**February 5, 2026
6:30 PM**

City of North St. Paul Planning Commission Report

Planning Commission Report

KWIK TRIP STORE #1169 CARWASH ADDITION

DEMOLITION PLAN

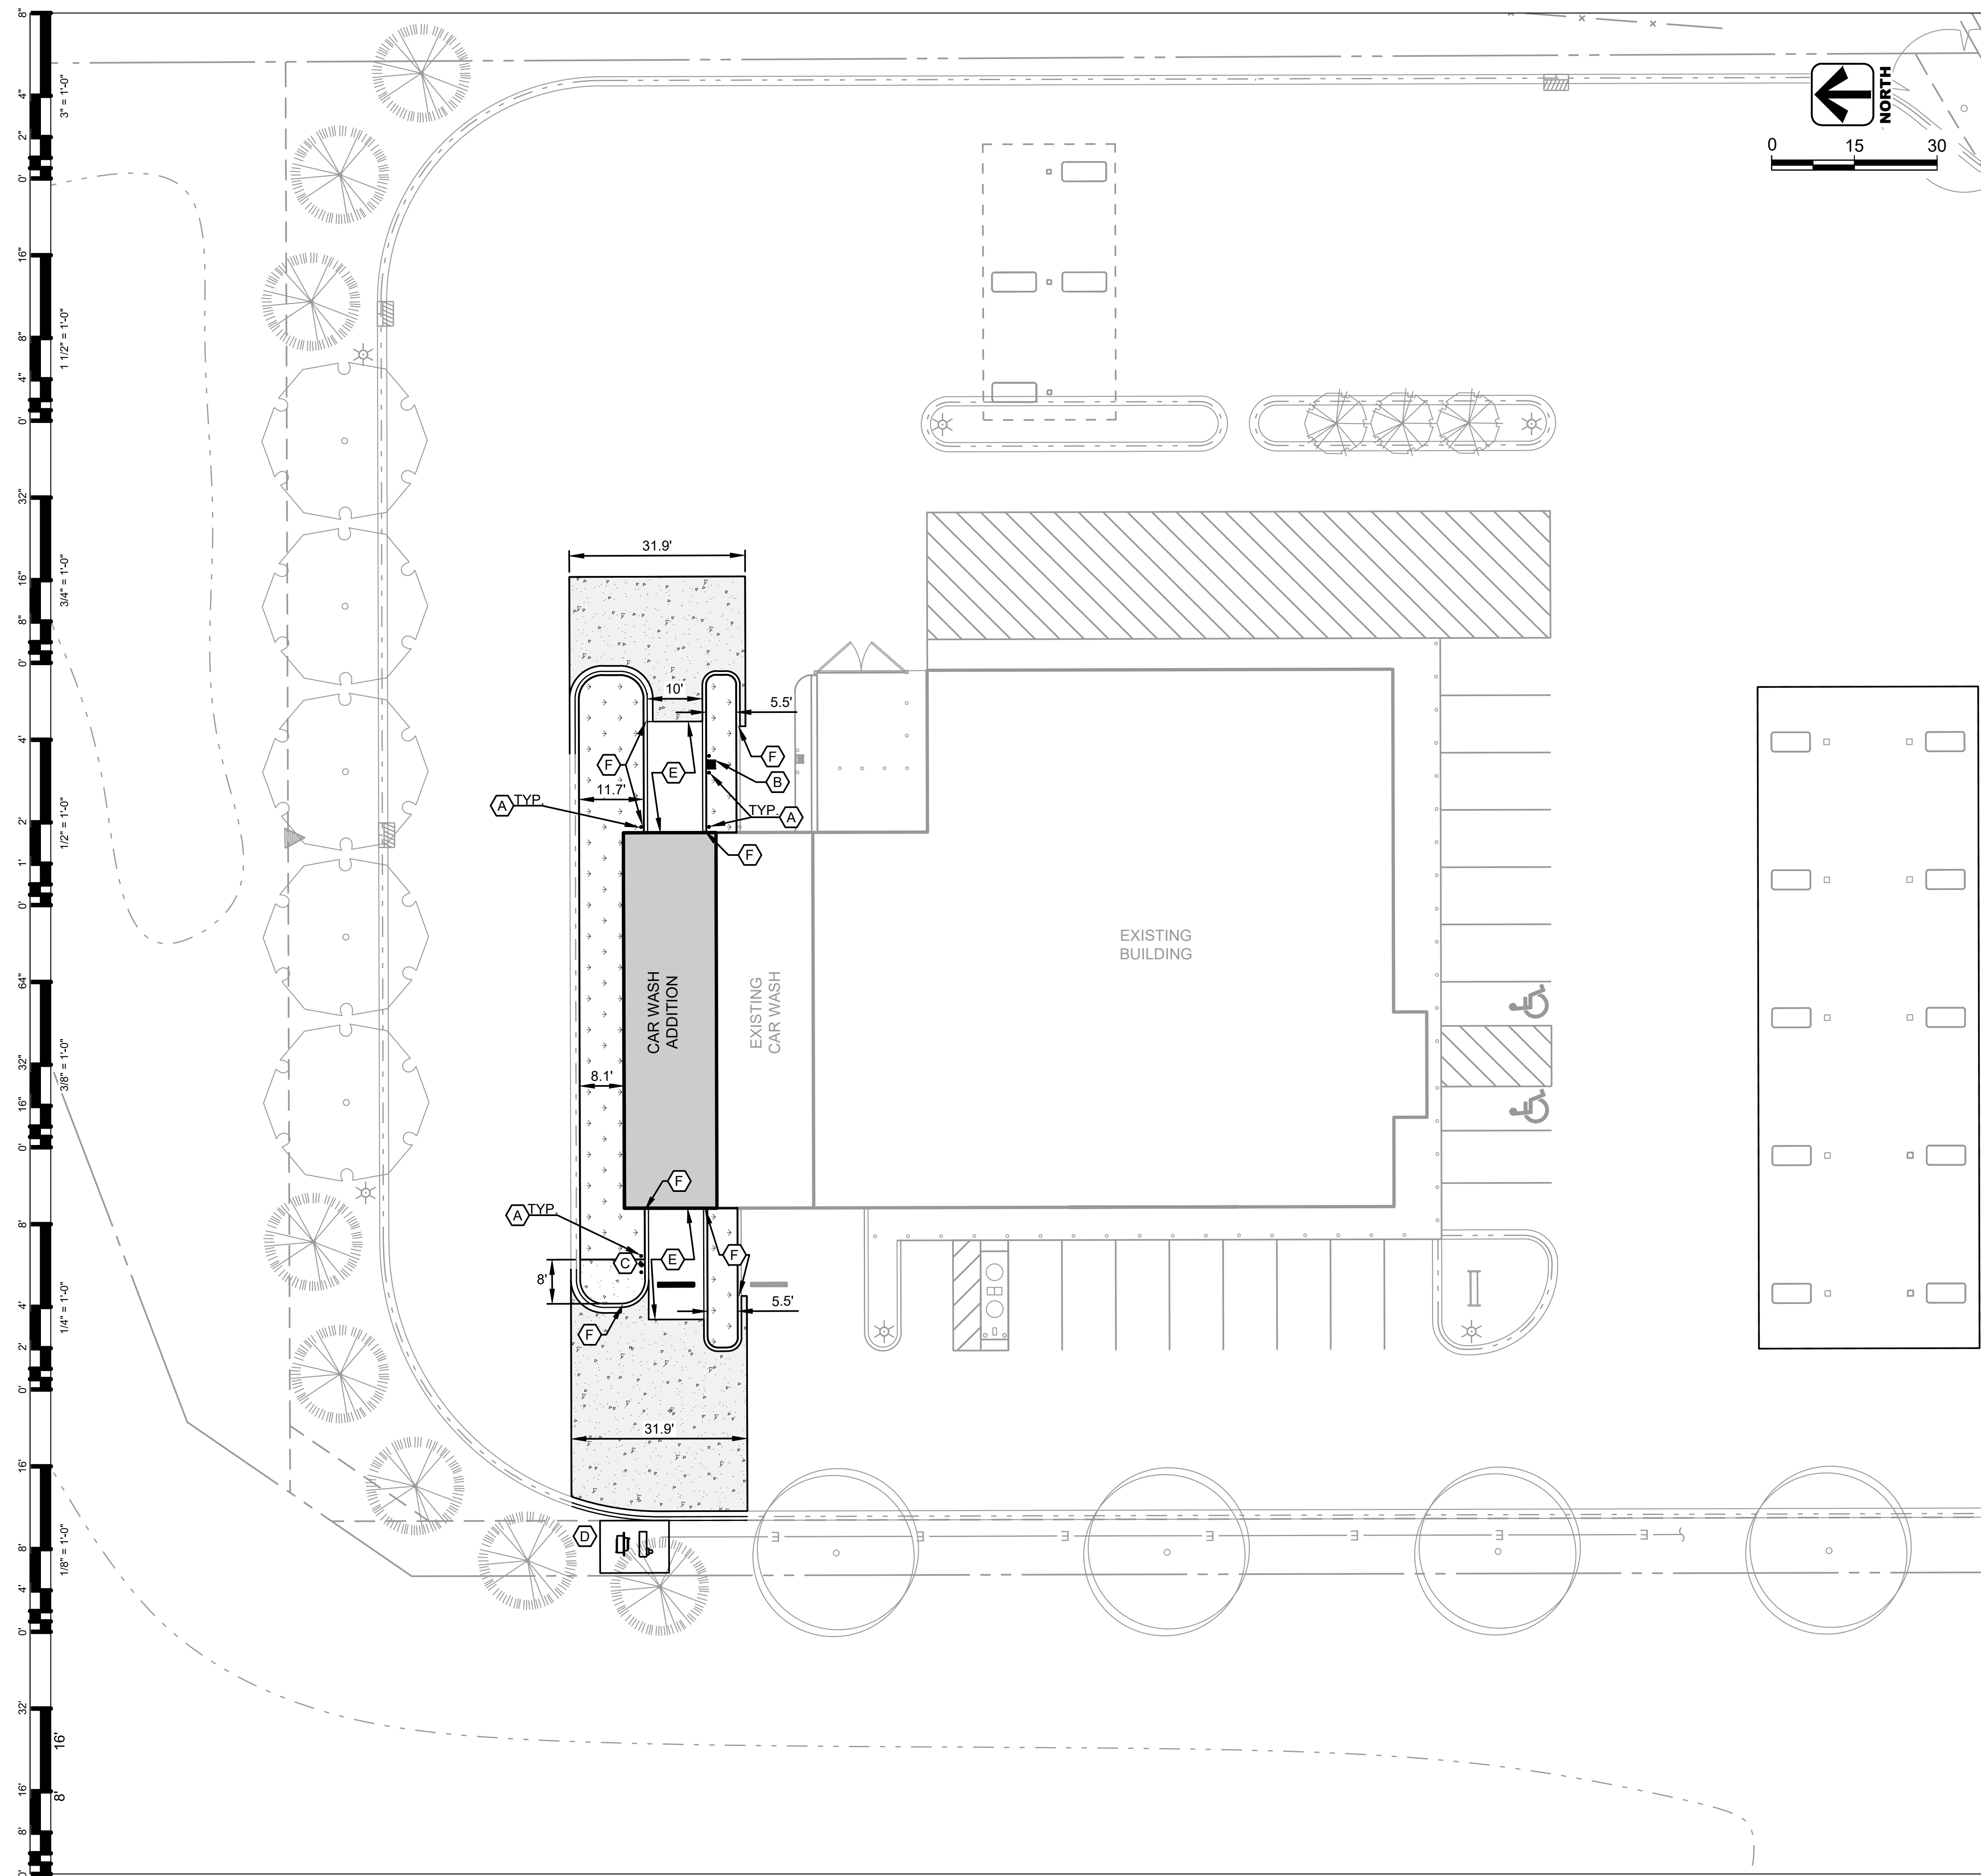
The proposed project demolition plan indicates four trees and 22 shrubs will be removed from the north side of the existing car wash to accommodate the car wash addition. The demolition plan also notes the contractor is to protect 2 trees near the proposed location of the on-site electric transformer. City staff are concerned these trees could be damaged by the placement of the transformer. The applicant should agree to move or replace the trees near the proposed location of the transformer. The proposed landscape plan specifies the planting of 4 trees and 45 shrubs in the area around the car wash addition. The mix and types of proposed trees and shrubs are generally acceptable.

The demolition plan shows the removal of one free standing light pole adjacent to the existing north side of the existing car wash. All other existing exterior lighting on the site will remain. The project plans do not show the addition of any new free standing light poles or exterior wall pack lights on the property.

Staff recommend that as a condition of approval the City require the applicant provide City staff a detailed exterior photometric lighting plan for the part of the site affected by the addition for City approval. This plan should show the location and height of all proposed freestanding light poles, the type of proposed light fixtures on the poles and the style of the exterior light wall packs to ensure the exterior lighting will meeting all City standards. Specifically, staff recommend the revised plan provide enough lighting in and around the drive aisle on the north and west sides of the car wash to ensure adequate visibility and safety for pedestrians and vehicles.
